Access Compliance Report

Public Rights-of-Way

Intersection ID: 2696	Main Street: HAWKSNEST_DR	Cross Street: RAVENCREST_DR	Location: SE
ADA ID: ED59581D26D7	Ramp Type: PerpDiag	Initial Pass/Fail: Pass	Overall Compliance: No
Severity Score: 10.25			
Codes/Mitigation Info/Possible Solution		Field Measurements/Component Compliance

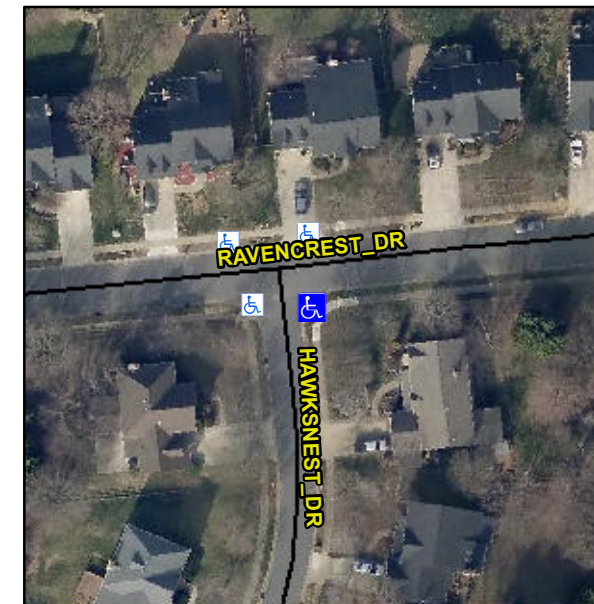
Not Found, R304.5.3, R304.2.1, R304.2.2-Perp, R304.3.2-Para, R305

Compliance	Description	Data	Compliance	Description	Data
N/A	Ramp Length (in)	48.0	Yes	Ramp Slope (%)	6.9
Yes	Ramp Width (in)	72.0	No	Ramp XSlope (%)	2.9
N/A	Flare Type LT	None	N/A	Flare Type RT	N/A
N/A	Flare Slope LT (%)	N/A	N/A	Flare Slope RT (%)	N/A
N/A	Flare Traversable LT?	N/A	N/A	Flare Traversable RT?	N/A
Yes	Landing Length (in)	49.5	No	DWS Provided?	No
No	Landing Width (in)	39.0	N/A	DWS Contrast?	No
No	Landing Slope (%)	5.0	N/A	DWS Length (in)	N/A
Yes	Landing X Slope (%)	2.0	N/A	DWS Full Width?	No
N/A	Landing Curb? (Y/N)	No	N/A	DWS Offset (in)	N/A
N/A	Shared Landing?	No			
Yes	Gutter Ponding?	No	Yes	Gutter Slope (%)	4.7
Yes	Gutter Lip Ht (in)	0.0	No	Gutter X Slope (%)	3.1
N/A	Painted X Walk1?	No	N/A	Painted X Walk2?	No
	X Walk 1 Direction	To N		X Walk 2 Direction	To W
N/A	X Walk 1 Width (in)	N/A	N/A	X Walk 2 Width (in)	N/A
	X Walk 1 Slope (%)	1.5		X Walk 2 Slope (%)	2.0
	X Walk 1 X Slope (%)	1.9		X Walk 2 X Slope (%)	1.7

N/A	Ramp inside XWalk1?	N/A	N/A	Ramp inside XWalk2?	N/A
	Road Slope (%)	1.9	N/A	Clear Space?	Yes
	Road X Slope (%)	2.4	N/A	Clear Space to XWalk (in)	N/A
Yes	Any Obstructions?	No	Yes	Storm Grate/Utility Hazard?	No
	Obstruction Type			Storm Grate/Utility Type	
		N/A			N/A
			Yes	Surface Condition? (G/P)	Good

Remove & Replace Curb Ramp With Two New Directional Ramps or Equivalent. Remove & Replace Gutter.
